ADDENDUM NO. 04

Northland Corridor Redevelopment Project Phase 4
631 Northland Ave.
Buffalo, NY 14211

Project No. 432607

Project Northland Corridor Redevelopment Phase 4 (BUDC) Addendum No. 4
631 Northland Avenue, Buffalo, NY Contract -
Wendel Project No. 432607 Date 10/31/25

5 SECTION DETAIL - MASONRY WINDOW INFILL
SCALE: 1 1/2" = 1'-0"

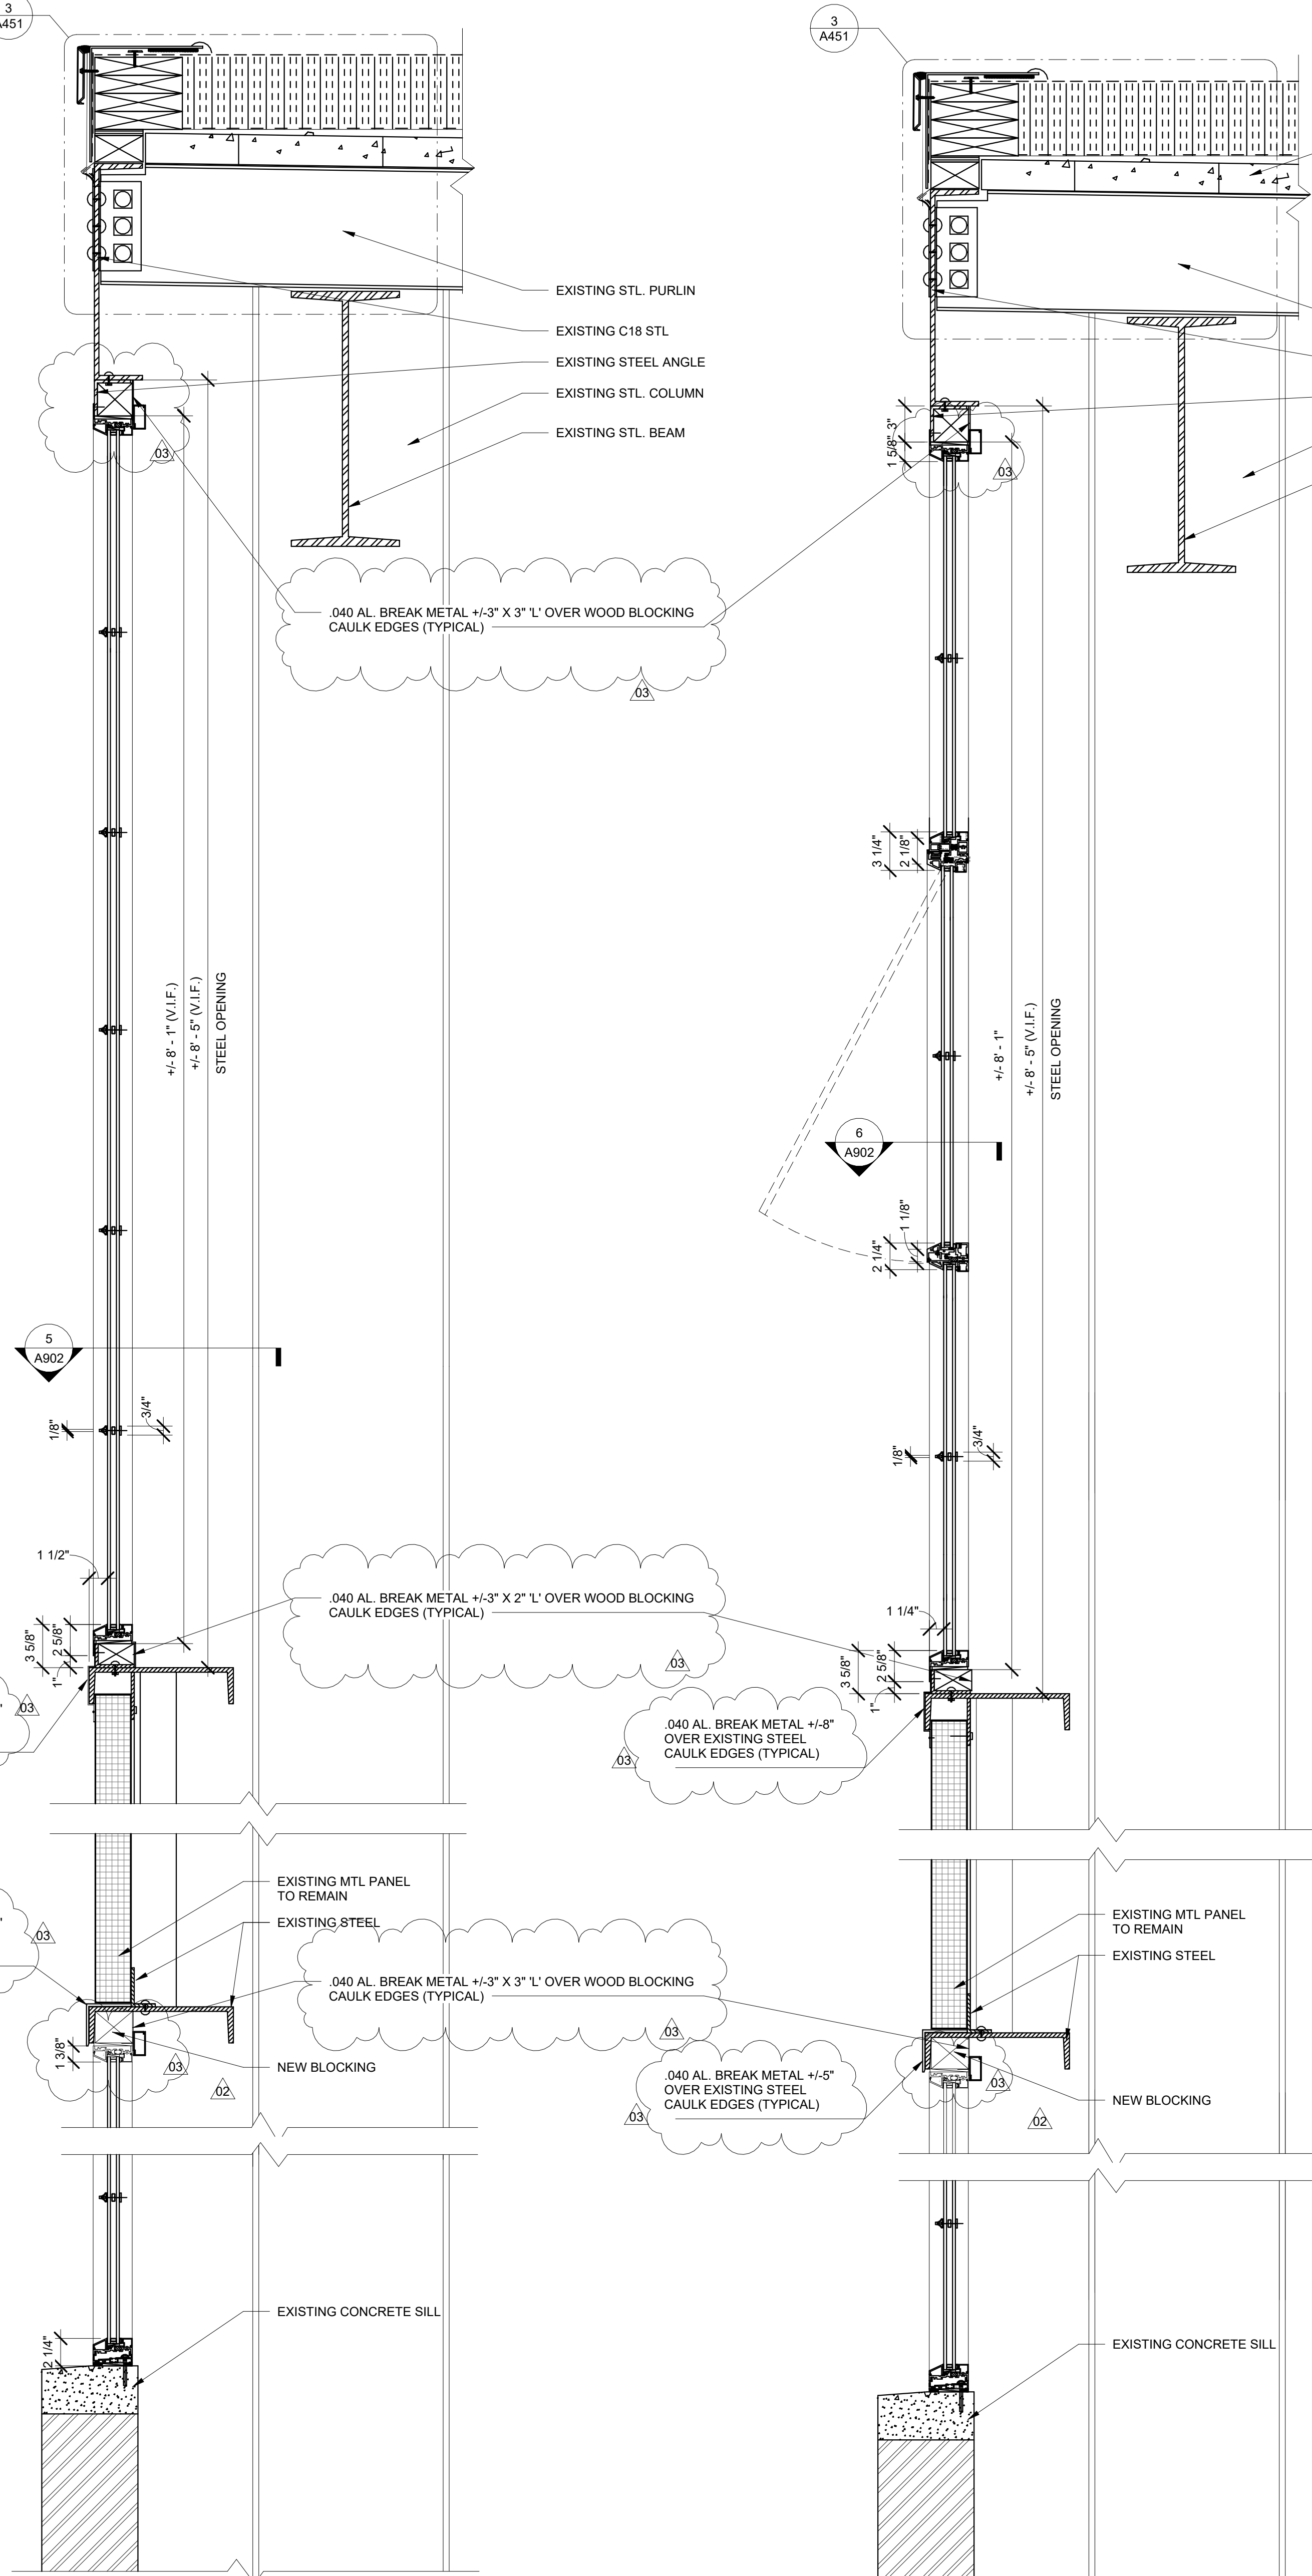
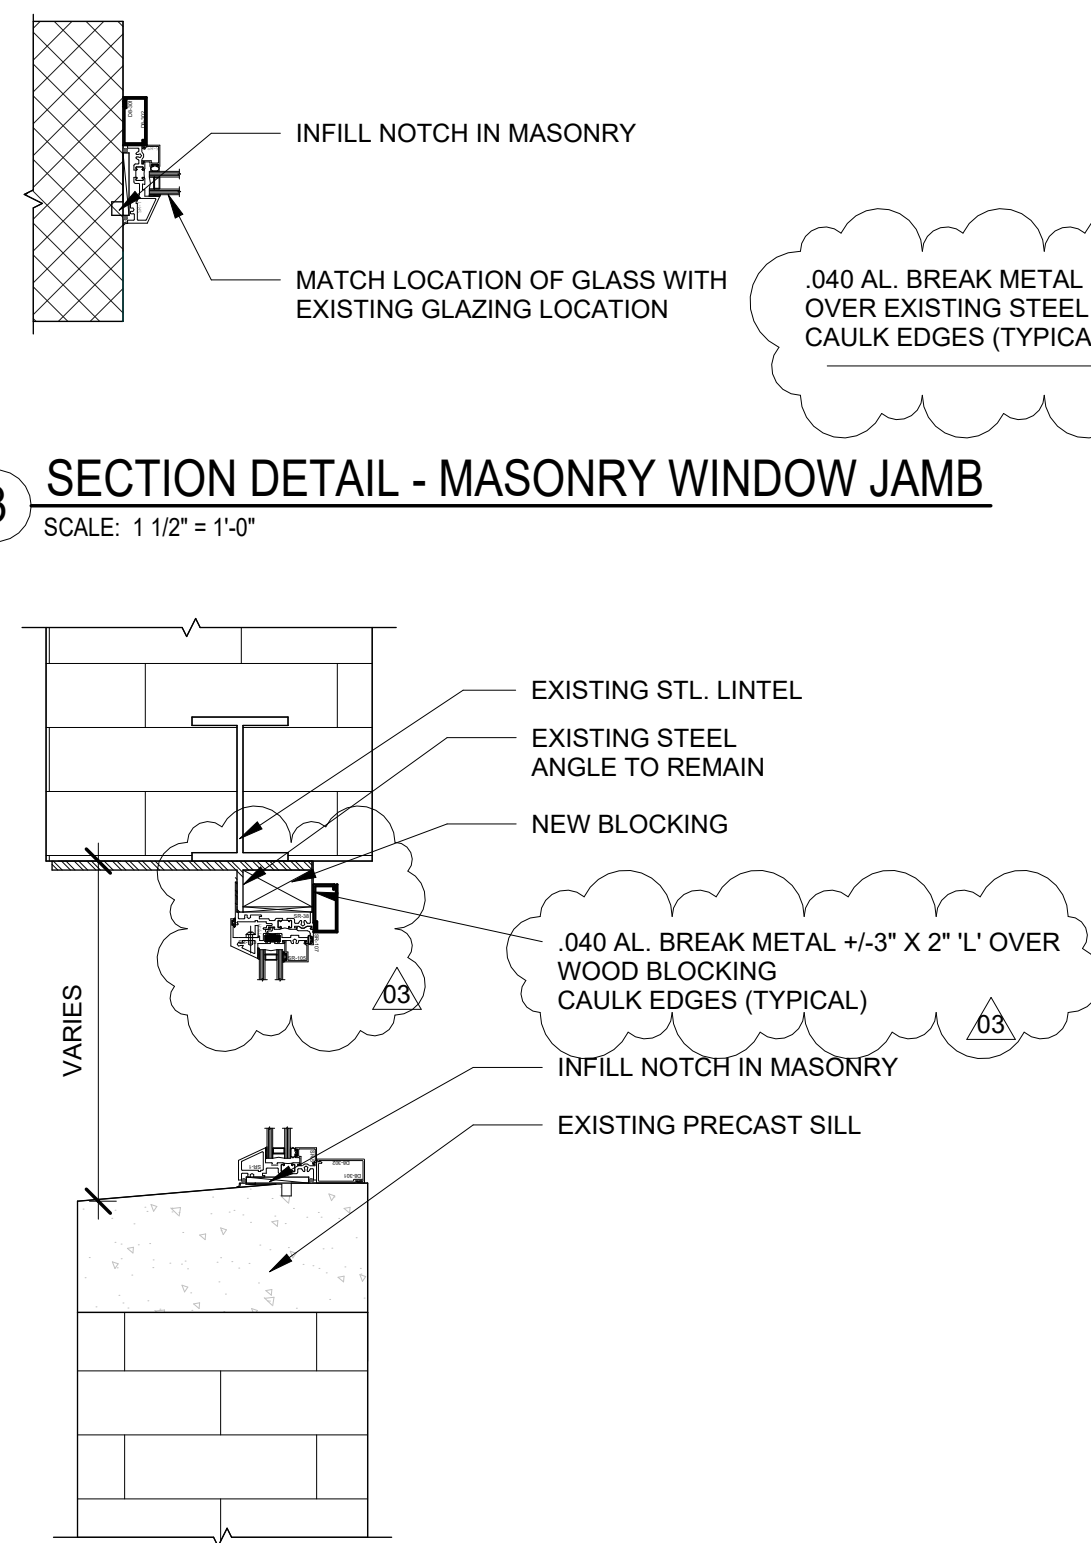
QUESTION: It appears that there are long runs with 3 pc mullions between each unit and a sill starter extrusion at the sill and interior snap trim and clip at the head, is that correct? Please clarify.

Section details 6 & 7 on A901 do not appear to show the 2nd floor window conditions for the head and sill. Is contractor to assume the head and sill shown in details 6 & 7 on A901 are the same as the 2nd floor windows?

Please reference A901: Detail 5/A901 just shows the window "floating" at the head. Is there to be wood blocking AND interior snap trim at this location?

Section 6 and 7/A901: Snap trim is detailed at the head of the first/lower section. Is this also to be at the second/middle section that is not shown? The upper section does not detail any snap trim, so I am unsure what the requirement is of the second/middle section.

Addendum #3 removed snap trim details 5, 6, 7 on A901. What should be used to capture the head the windows at detail 6 & 7. Would a head receptor be acceptable in these locations, or what is the intent here? Please confirm snap trim is still required per details 3 & 5 (sill location) on A901.

ANSWER: Please refer to revised drawing A901 attached for further clarity.

The head detail is the same on the 1st and 2nd rows of windows per the attached A901. The head detail on the 3rd row is shown and slightly different. The sill detail is the same on the 2nd and 3rd rows. The sill detail is different on the 1st row as shown.

There is break metal required. The wood blocking on the interior will receive .040 break metal. Approximate sizes have been clarified on the attached A901. The exterior will receive the same break metal to cover the existing steel. Photographs of the existing condition and selective demo are attached for reference. There is currently no flashing provided at the head of the 3rd row of windows. Note that Sections 6 & 7 on A901 only show the first and third rows of windows. The second row of windows has the same details and requires the same break metal flashing and blocking.

CLARIFICATION: Snap trim IS REQUIRED and clarified as such on the revised A901. Please disregard Article 5 in Addendum 03 which removed the snap trim.

REPLACE: Drawing A901 with the revised attached to this addendum.
